HARTING Product Change Notification

PCN/19/012/C+N

Title: M12 Power L-code PFT - External

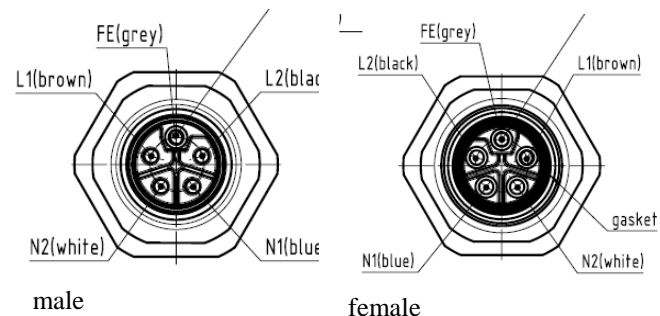
Change – New Pin assignment!

OLD

Potenzial	Contact-Number M12 L-code	Color coding
L1	Pin 1	brown
N1	Pin 2	blue
L2	Pin 3	black
N2	Pin 4	white
FE	Pin FE	grey

NEW

Potenzial	Contact-Number M12 L-code	Color coding
L1	Pin 1	brown
N1	Pin 3	blue
L2	Pin 4	black
N2	Pin 2	white
FE	Pin FE	grey

This change is in order to be compliance with the new PROFINET specification.
